**Project
T10/1683-D**

Revision 13
27 September 2007

**Information technology -
SCSI Architecture Model - 4 (SAM-4)**

Summary of Comments on SCSI Architecture Model - 4

Figure 2 — SCSI document structure

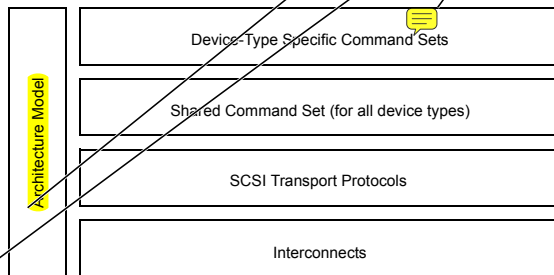
I recommend that at least one "e.g." be added either in the four rows in figure 2, in the descriptive text that follows, or both. See SBC-3 for an example.
- Status: George Penokie Rejected 10/29/2007 4:06:27 PM -05'00'

Emulex-001
Page: 2 first sentence below Figure 2 - "roadmap" s/b "document structure"
- Status: George Penokie Accepted 10/30/2007 2:17:02 PM -05'00'

Copied the SBC-3 figure into SAM-4.
- Author: relliott Subject: Highlight Date: 10/28/2007 10:45:42 PM -05'00'

Figure 8 — Object diagram conventions

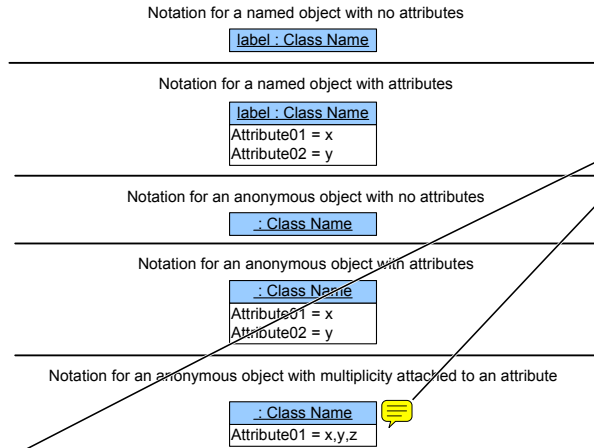
Author: George Penokie Subject: Note Date: 10/29/2007 3:30:04 PM -05'00'
 Having multiple values for an attribute is not valid for an instance of a class. It has been deleted from the figure. Note this change was also made to the style guide.

Figure 19 — SCSI Initiator Device class diagram

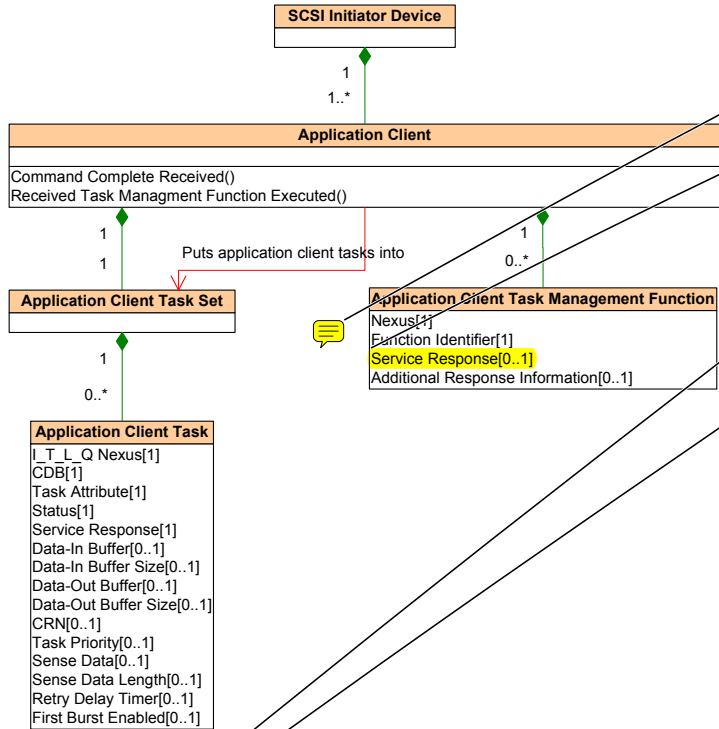
Author: reilott Subject: Note Date: 10/8/2007 6:53:04 PM -05'00'
 Nexus and Function Identifier should be swapped in figure 19 and in sections 4.5.11.2 and 4.5.11.3 to match the SCSI Target Device side in figure 22 and following sections. (or the target side should be swapped to follow this)

Figure 22 — Logical Unit class diagram

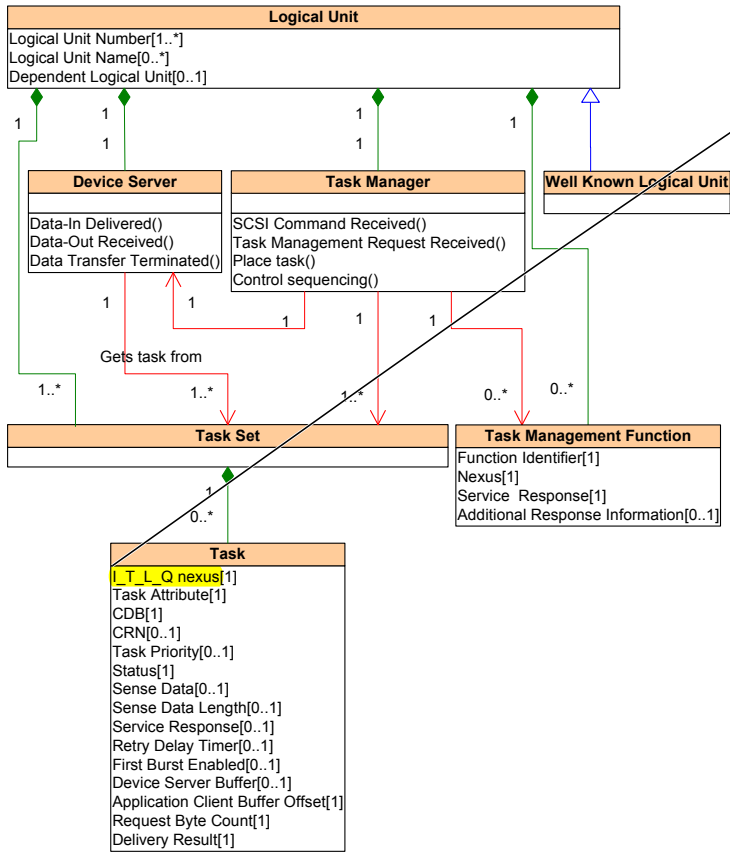
There is no class with that name, and it doesn't appear in figure 22.

Author: relliott	Subject: Highlight	Date: 10/8/2007 6:46:29 PM -05'00'
4.5.24.3 should be swapped with 4.5.24.2 to match the order the attributes are listed in figure 22.		
Status	George Penokie Accepted	10/30/2007 5:11:35 PM -05'00'
Author: sublerp	Subject: Sticky Note	Date: 10/25/2007 6:21:35 PM -05'00'
Should this say "receives a task or a task management function specifying a W-LUN" ?		
Status	George Penokie Accepted	10/30/2007 5:13:52 PM -05'00'
Author: George Penokie	Subject: Note	Date: 10/30/2007 5:13:49 PM -05'00'
Yes		
Author: relliott	Subject: Highlight	Date: 10/29/2007 11:16:28 AM -05'00'
selection of incorrect logical units s/b incorrect logical unit numbers		
Status	George Penokie Completed	12/26/2007 11:07:34 AM
Author: George Penokie	Subject: Note	Date: 12/26/2007 11:16:12 AM
Changed to << addressing an incorrect logical unit >> Changed globally. Also, changed all << incorrect LUN >> to << incorrect logical unit number >>.

Status
George Penokie Accepted 10/30/2007 5:05:22 PM -05'00'
Author: George Penokie Subject: Note Date: 10/30/2007 5:05:06 PM -05'00'
Deleted the entry as it was a hold over from a previous version of the UML.
